Interactive comment on “Methane cross-validation between three Fourier Transform Spectrometers: SCISAT ACE-FTS, GOSAT TANSO-FTS, and ground-based FTS measurements in the Canadian high Arctic” by G. Holl et al.

We thank the anonymous reviewer #1 for their feedback. Below, we include the comments indicated by the anonymous reviewer along with our response.

Fig. 1. Repetition of Figure 17 from the manuscript, but for the linear regression, excluding any data points that deviate from the median by more than 5 times the median absolute deviation.

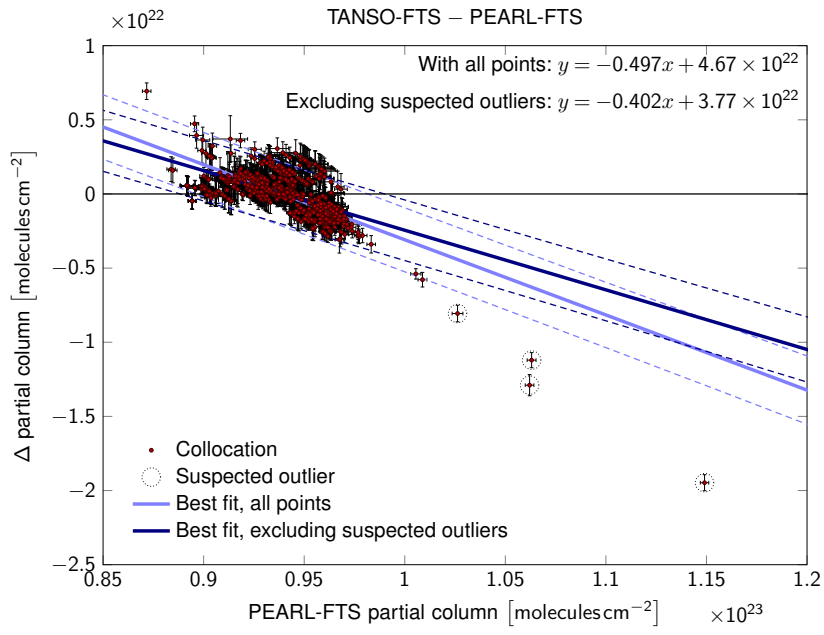
Figure 17 and discussion on page 1322, Lines 15-17: There are 4 points which look to be outliers on this plot. Outliers can greatly influence linear regression. Was linear regression without the outliers performed to make sure these points do not have a major effect on the result?

Although we are not convinced that the data points that deviate from the bulk are technically outliers (they might correspond to physically real situations), we have repeated the regression while removing any data points that deviate from the median by more than 5 times the median absolute deviation.

Figure 1 (shown at end of response) shows a repetition of Figure 17 from the manuscript, but with suspected outliers removed as described. The new prediction band lies slightly higher than the old one, but there is still considerable overlap between the two. Therefore, we conclude that those data points (which may or may not be outliers) do not significantly affect the regression. In the manuscript, we have replaced Figure 17 by the new figure and adapted the text accordingly.
